1. Planning Board Meeting Materials 2026-01-05

AGENDA
York Planning Board Meeting
January 5, 2026
7:00 PM
York Public Library

TO: The York Planning Board
FROM: Brendan J. H. Summerville, Town Planner
DATE: 5 January 2026
RE: Sketch Plan Application Review – 60 Main Street
Map/Lot 0020-0001-A

TO: Planning Board
FROM: Brendan J. H. Summerville, Town Planner
DATE: 5 January 2026
RE: Sketch Plan Application Review – 985 & 995 US Route 1
Map 94 Lot 75A and Map 30A Lots 18 & 29

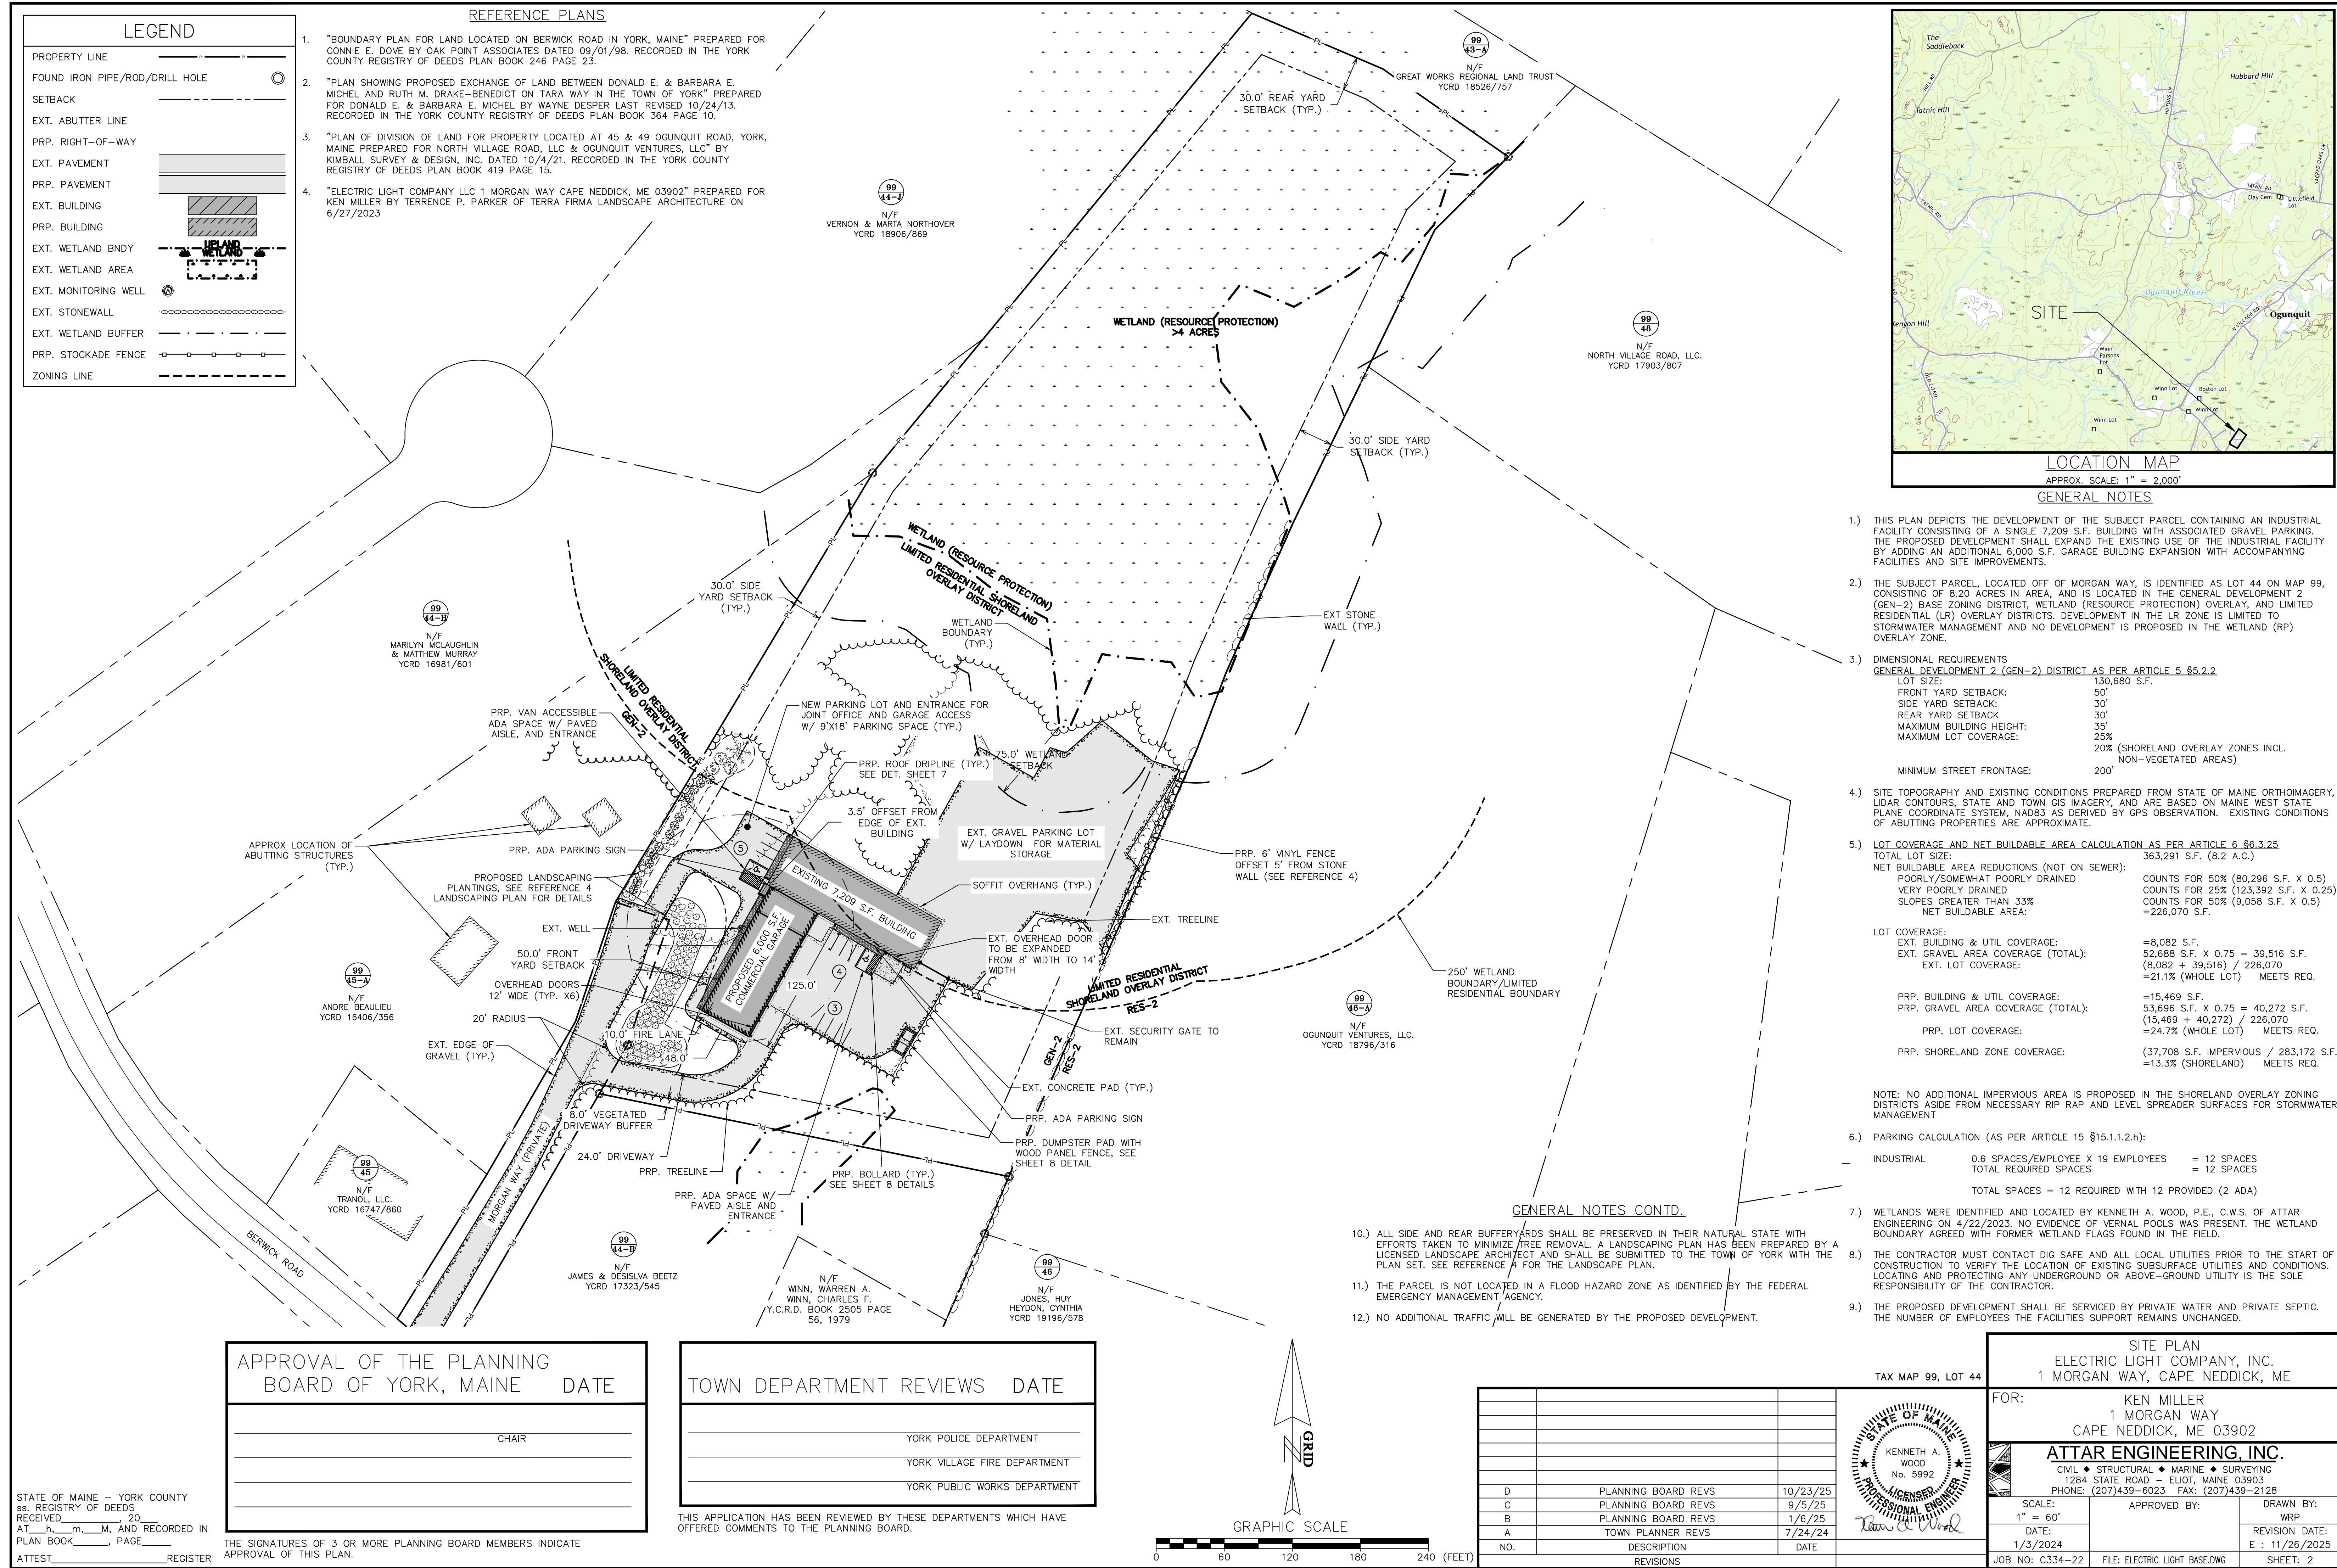
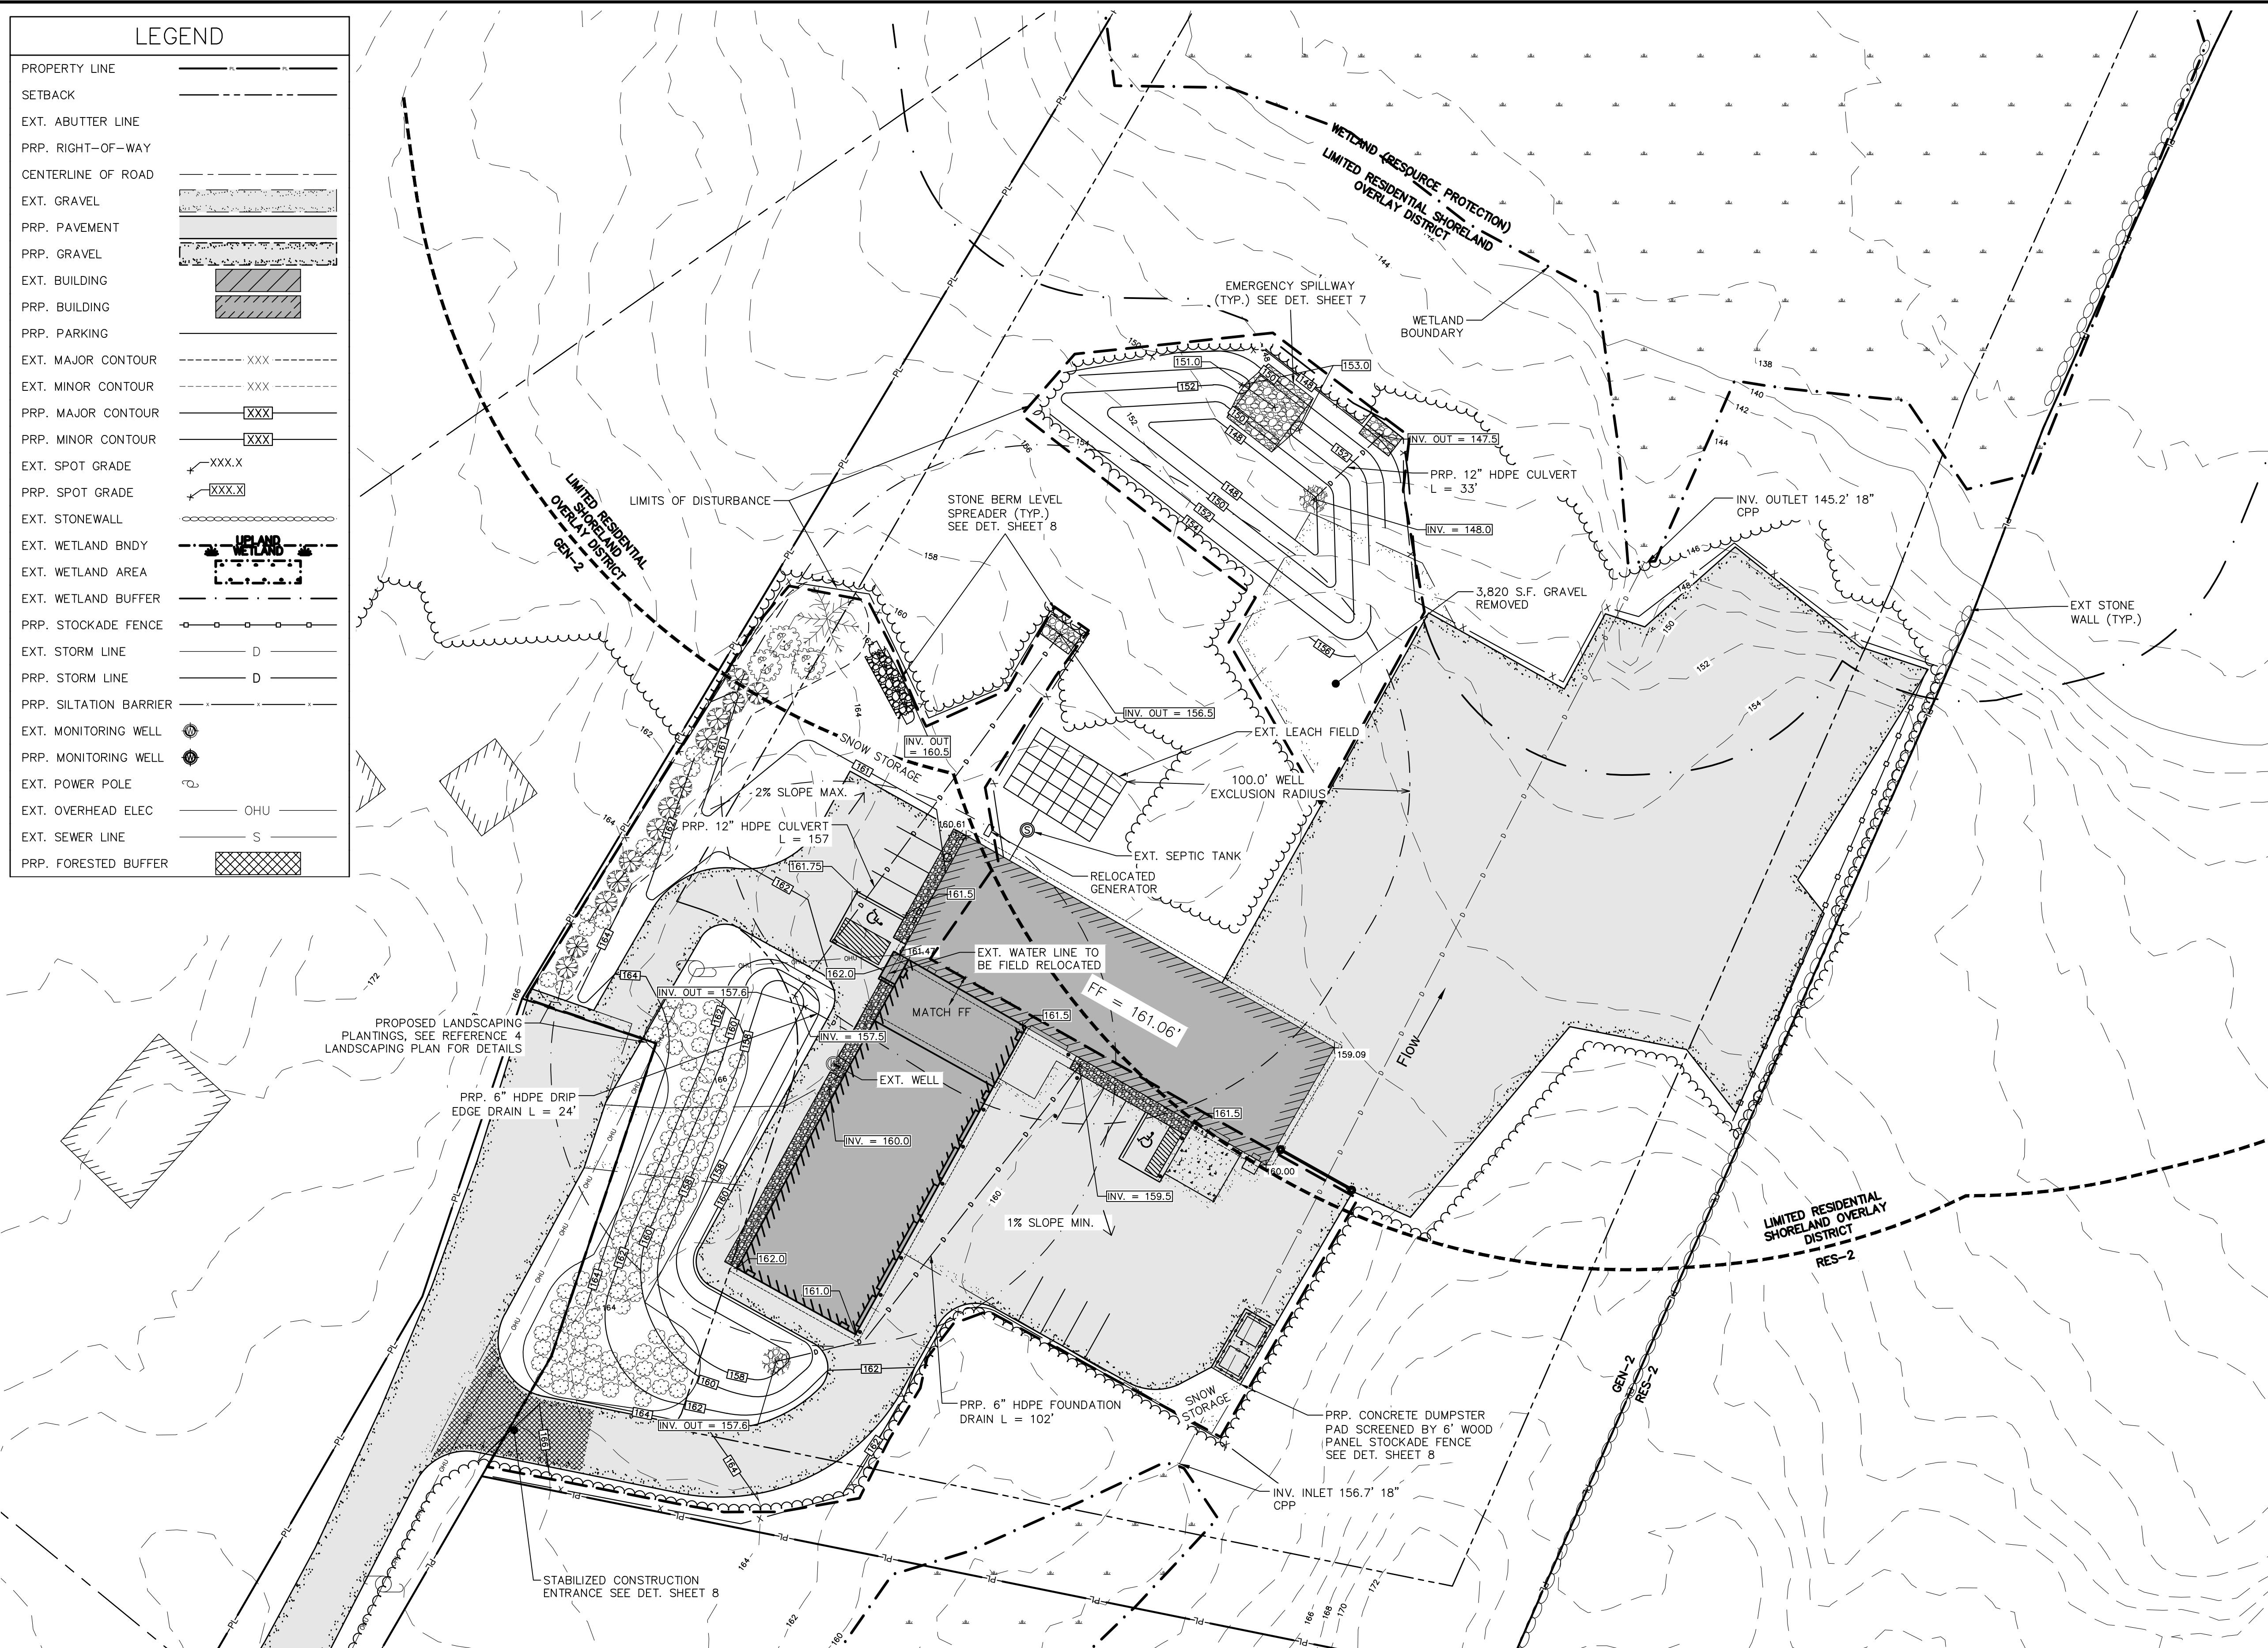
6. Demonstration of total impervious surface ratio and coverage is not entirely clear and needs further clarity and information. **The plans have been revised. The additional calculations, however, (Plan Note 5 on sheet 2) are not clear. (see comment 2.b below)**

- b. In the GEN-2 zone there is a requirement not to exceed 25% impervious surface ratio for the lot. [and 20% for the area within the Shoreland Overlay Zone subdistrict Limited Residential per Article 8]. The plans (Sheet 2, Site Plan) appear to only include the buildings in the coverage calculations. See the Definitions section of the Zoning Ordinance for more information on calculating 'Impervious Surface Ratio'. The applicant has revised the plan, however, the calculations, (Plan Note 5 on sheet 2) reflect only gravel area for coverage (under 'PRP. SHORELAND..') and the note below states 'no additional impervious area' in the shoreland zone. The plans reflect approximately half the existing building within the shoreland zone, but the area doesn't appear to be reflected in the shoreland calculations. The riprap associated with the stormwater pond should be reflected in the total coverage amounts. The Applicant should confirm and revise accordingly.
